**TOWN OF NEWBURGH
PLANNING BOARD
TECHNICAL REVIEW COMMENTS**

PROJECT: MADAN SUBDIVISION
PROJECT NO.: 20-06
PROJECT LOCATION: SECTION 1, BLOCK 1, LOT 132
REVIEW DATE: 29 MAY 2020
MEETING DATE: 4 JUNE 2020
PROJECT REPRESENTATIVE: MECURIO-NORTON-TAROLLI-MARSHALL ENGINEERING

Re: Job No. 2822-110B
Tax Parcel 1-1-32
Town of Newburgh, Orange County
757 Orchard Drive
Residential Subdivision

Survey Map & Subdivision Plan for Lands of Robert P. & Deborah C. Madan

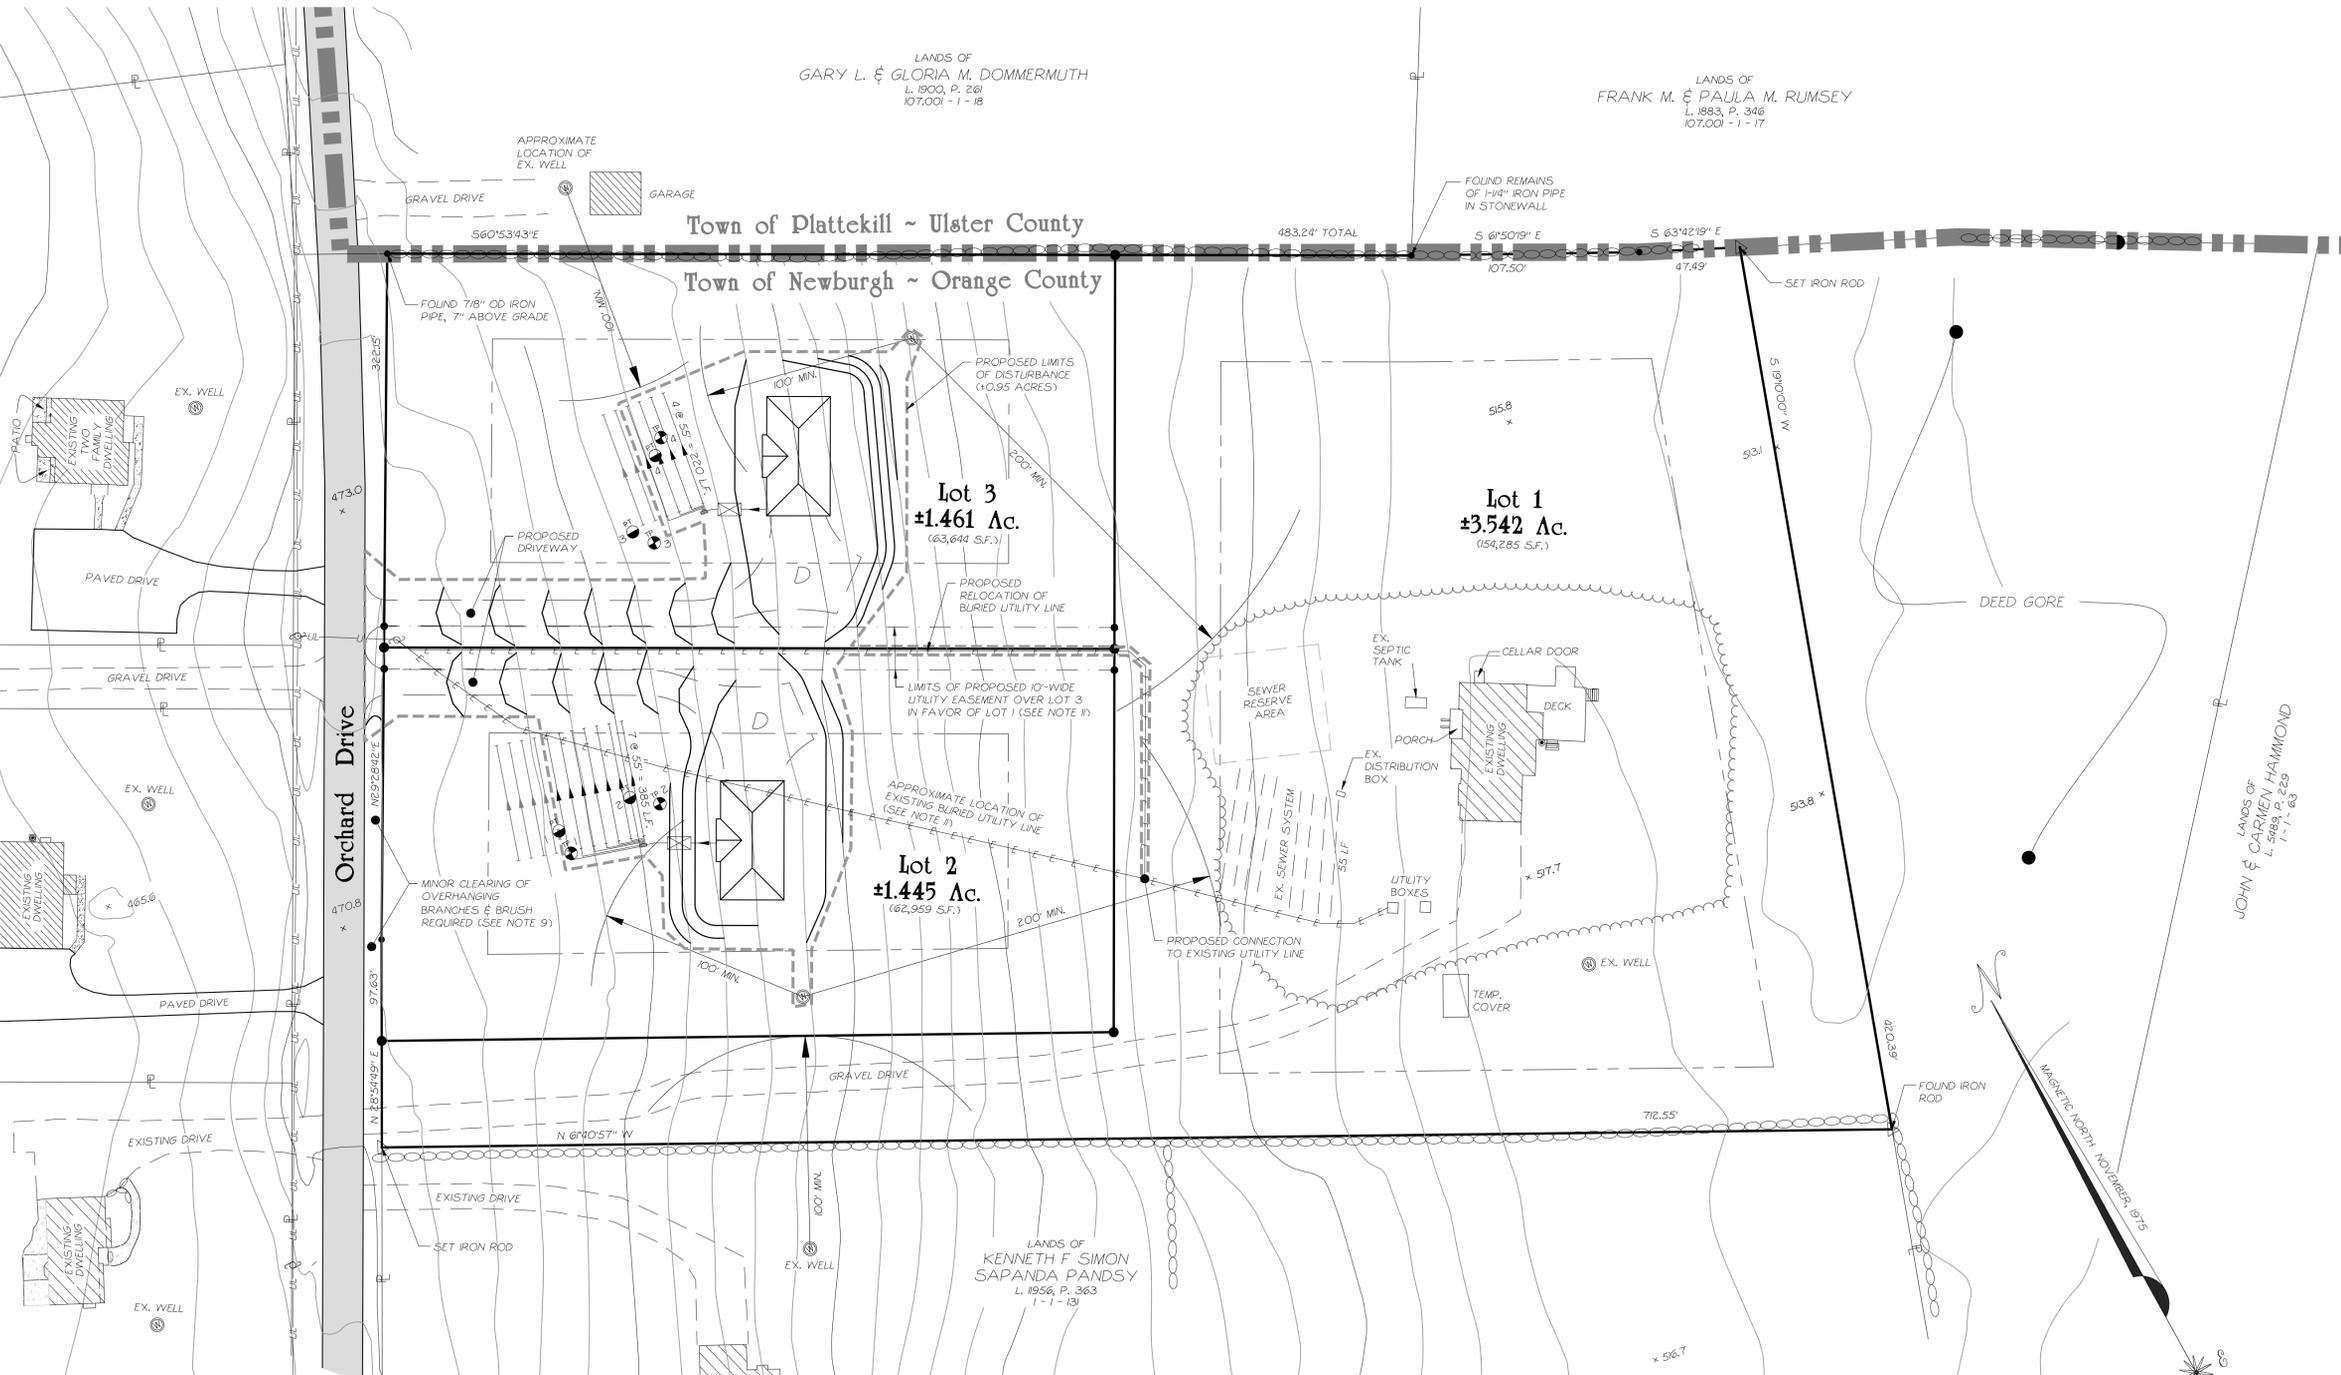
1. The proposed utility easement has been widened to 20-feet. The applicant has agreed to relocate the utility line prior to the filing of the subdivision map. We anticipate this will be a condition of approval for the maps the signed.

2. The Sight Distance Table on sheet 2 has been revised to specify the sight line to the left out of the proposed driveways requires minor clearing of overhanging branches and roadside brush along the project frontage. A note to this effect has been added to the referenced area on sheet 1. No major clearing is required other than trimming of vegetation that overhangs into the right-of-way. We do not believe a permanent clearing easement is required. Note 9 has been included on sheet 1 specifying individual lot owners are responsible for clearing and maintaining 13 feet from the edge of pavement along Orchard Drive to maintain adequate sight distance.

3. Note 10 has been included on sheet 1 referencing the required as-built sewer certification prior to the issuance of a certificate of occupancy. If different wording or notation is required, please advise.

- 9) LOT OWNERS SHALL BE RESPONSIBLE FOR CLEARING AND MAINTAINING 13 FEET FROM THE EDGE OF ORCHARD DRIVE PAVEMENT TO MAINTAIN ADEQUATE SIGHT DISTANCES.

- 10) PRIOR TO THE ISSUANCE OF A CERTIFICATE OF OCCUPANCY FOR ANY SEWERAGE SYSTEM SUBJECT TO THE PROVISIONS OF LOCAL LAW 1, 1989, THE TOWN OF NEWBURGH BUILDING INSPECTOR MUST RECEIVE AN "AS-BUILT" PLAN OF SUCH SYSTEM BEARING THE FOLLOWING CERTIFICATION OF A PROFESSIONAL ENGINEER OR OTHER AUTHORIZED DESIGN PROFESSIONAL AS SET FORTH ABOVE: "I HEREBY CERTIFY TO THE TOWN OF NEWBURGH THAT THE SEWERAGE SYSTEM DEPICTED ON THIS PLAN HAS BEEN DESIGNED AND INSTALLED IN ACCORDANCE WITH THE NEW YORK STATE PUBLIC HEALTH LAW AND ALL REGULATIONS PROMULGATED THEREUNDER."

- 11) THE EXISTING BURIED UTILITY LINE SERVING THE DWELLING ON LOT 1 WILL BE RELOCATED AS SHOWN, SUBJECT TO A PROPOSED UTILITY EASEMENT THROUGH LOT 3 IN FAVOR OF LOT 1.
